Street Management Advisory Committee

Date 18th September 2013
Agenda item: 5
Wards: Village
Subject: Wimbledon Area Traffic Study – Burghley Road Traffic Calming Measures
Lead officer: Chris Lee, Director of Environment & Regeneration
Lead member: Councillor Andrew Judge Cabinet Member for Environmental Sustainability & Regeneration.
Forward Plan reference number: N/A
Contact Officer: Mario Lecordier (020 8545 3202)

Drawing No: Z36-24-192-1
Revision: B
Classification: DRAFT
Scale: N.T.S.

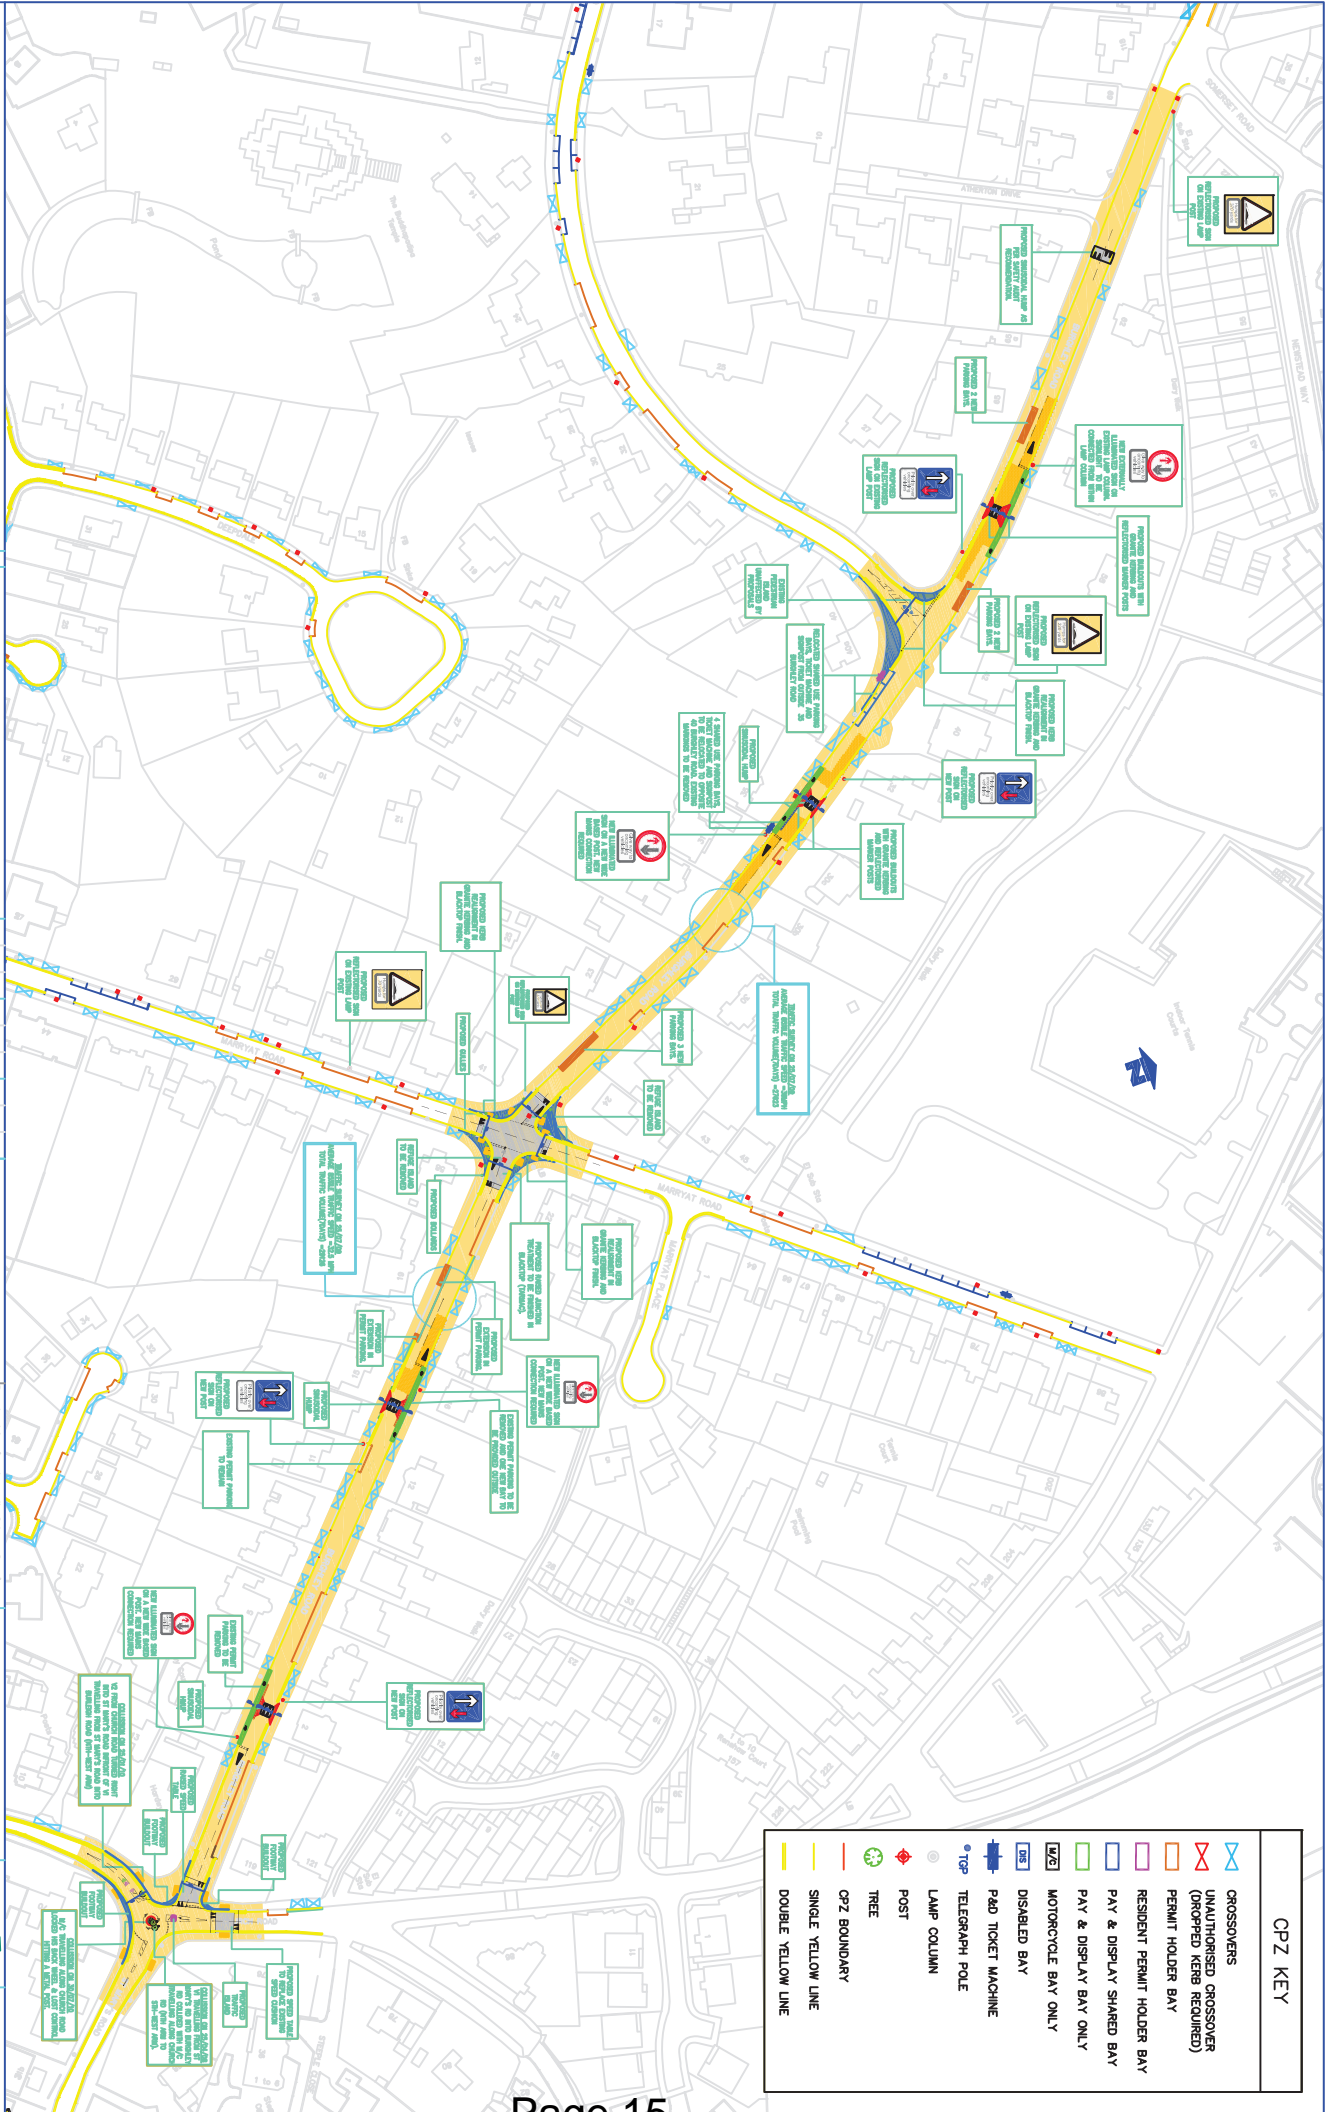
- 4.4.1 Majority of the representations were in support of the overall proposals to reduce traffic speeds in Burghley Road. However, concerns were raised regarding the proposed measures at the junction of Burghley Road/Church Road/St Mary's Road. These concerns relate to the raised speed table in Burghley Road, the footway build-out and the traffic island in Church Road at its junction with Burghley Road.

- 4.4.2 Comments were also received regarding the parking bays within the vicinity of 42 and 58 Burghley Road, as some residents feel it would restrict sightlines, as they exit their respective crossovers.

- 4.4.3 Some residents also feel the traffic calming measures in Burghley Road is overkill as the intention of the proposals is to slow traffic and not to stop them.

- 4.4.4 A comment was also received regarding reduced access to driveways, on-street and off-street parking.

The proposed measures at this location will improve safety by ensuring speeds are reduced within the vicinity of the mini-roundabout and also prevent drivers from St Mary's Road over-running this mini-roundabout into Burghley Road. Thereby reducing the number and severity of any collisions at this location.

It is unlikely these parking bays will restrict sightlines, as sufficient gap will be allocated between the parking bays and the vehicle crossovers. In addition, the footway build-out and the sinusoidal road humps within the vicinity of 58 Burghley Road will compel drivers to lower their speeds at this location. Hence, improve safety as residents exit their crossovers by driving out into the public highway instead of reversing.

The primary objective of the proposals is to reduce and maintain low speed. According to the speed surveys an 85%ile speed (speed at which 85 out of 100 vehicles surveyed travel at) of 42.7mph was recorded within the vicinity of 58 Burghley Road and 108 vehicles were recorded travelling above 56mph. Whilst the proposed road humps will reduce speed, the proposed priority traffic flow system will interrupt the speed at which these drivers travel and improve safety.

Access to driveway will not be affected by the proposals and the proposed features will improve safety by maintaining reduced speeds. Any removed parking spaces have been compensated elsewhere to minimise the overall loss. The Council has offered and consulted on a few options and these particular proposals are supported by the majority of residents. It is appreciated that some residents may be dissatisfied with the idea of having the features immediately outside their property; however, the locations of the proposed features have been strategically identified based on site constrained and suitable intervals between each feature to ensure a constant reduced speed along the road. It is considered that the overall benefits to all road users outweigh the preception of convenience that the measures may cause to some residents
